**REPORT FOR ACTION****Application for Four Variances, Each Subject to Four Conditions, Respecting One Third Party Electronic Ground Sign - 3639 Dufferin Street**

Date: August 04, 2020
To: Sign Variance Committee
From: Manager, Sign By-law Unit, Toronto Building
Wards: York Centre (Ward 06)

Pattison Outdoor (the "Applicant") has been authorized by the owner of the property municipally known as 3639 Dufferin Street (the "Premises"), Suncor Energy Products Partnership, to apply for four variances, each subject to four conditions, required to allow for a permit to be issued for one third party electronic ground sign with two sign faces, displaying electronic static copy (the "Proposed Sign") on the Premises.

Figure 1: Sign District Map Excerpt - 3639 Dufferin Street

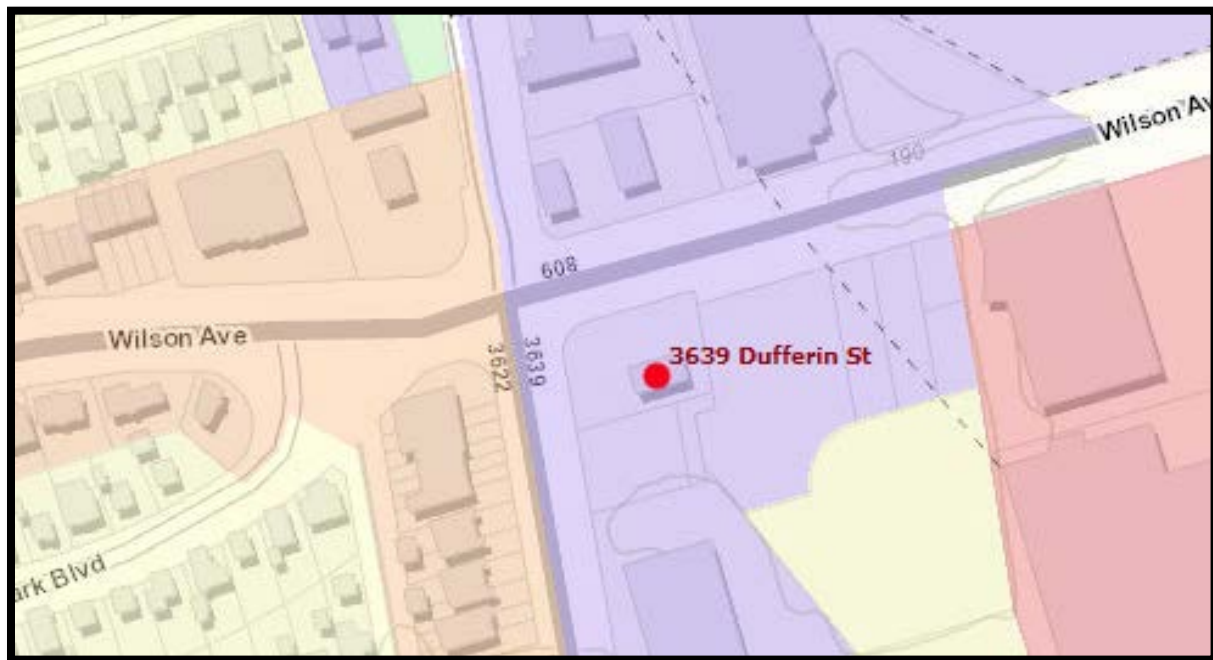
West: Commercial Residential (CR) Sign district, two story mixed use building with commercial tenants, on the first floor, including Benjamin Moore and Coffee Time, and residential tenants on the second floor.

Figure 2: Overhead view of Proposed Sign and the lighting impacts on certain nearby premises (150 NITS)

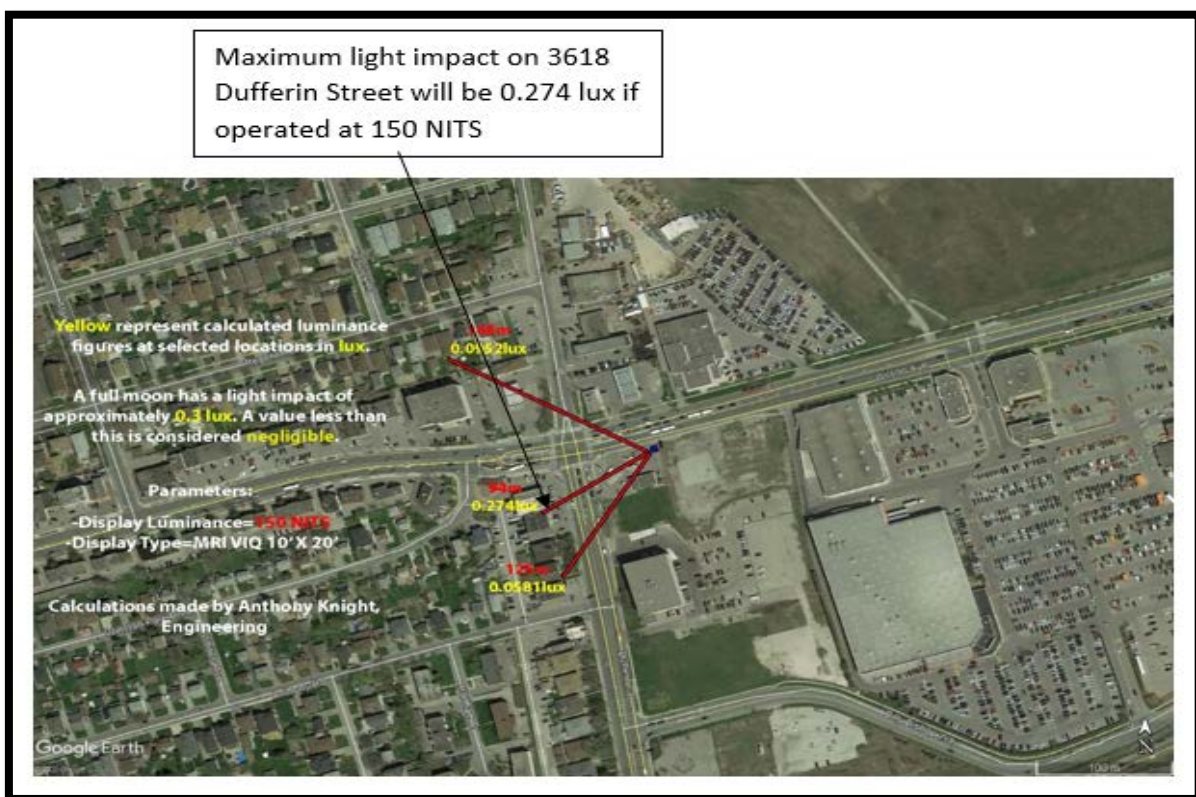
Lighting impact analysis has been conducted on July 21, 2020 by Anthony Knight P.Eng, to assess possible significant light impact on the residential uses located to west of Dufferin Street (the "July 21, 2020, Lighting Analysis"). The submitted report concluded that the lighting impact on the residents located in CR Sign District located at south-east corner of Wilson and Dufferin, is negligible. However, the report's conclusion requires the Proposed Sign to operating at 150 NITS between sunset and sunrise, and to contain the north-west/north-east orientation of the sign faces. (See figure 2 below)

The July 21, 2020, Lighting Analysis assessed the possible significant light impact on the residential uses located to west of Dufferin Street. The submitted report concluded that the lighting impact on the residents located in CR Sign District located at south-east corner of Wilson and Dufferin, is negligible. However, the report's conclusion requires the Proposed Sign to operating at 150 NITS between sunset and sunrise, and to contain the north-west/north-east orientation of the sign faces

- b) Notwithstanding subsection 694-18.E. (5) the illumination of the Proposed Sign shall not exceed 150 nits during the period between sunset and sunrise;

Figure 4 – Sign District map of the Premises and surrounding area

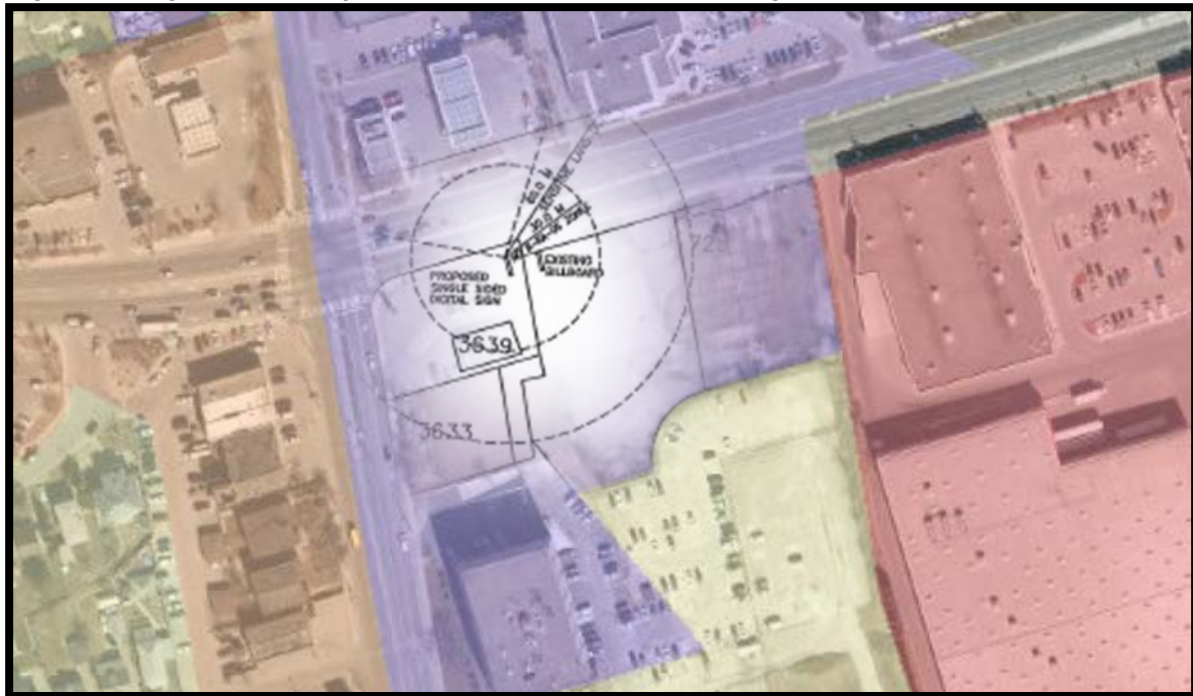
There are also Residential (R) Sign Districts located behind the CR Sign Districts to the west, however the visibility of the Proposed Sign from this R Sign District is completely blocked by the commercial buildings along the southwest corner of Dufferin Street and Wilson Avenue (See the Sign District Map Excerpt Figure 3 below).

In addition, v-shaped configuration rather than back-to-back will help direct the sign copy and illumination away from the R Sign District to the south and the CR Sign District to the west.
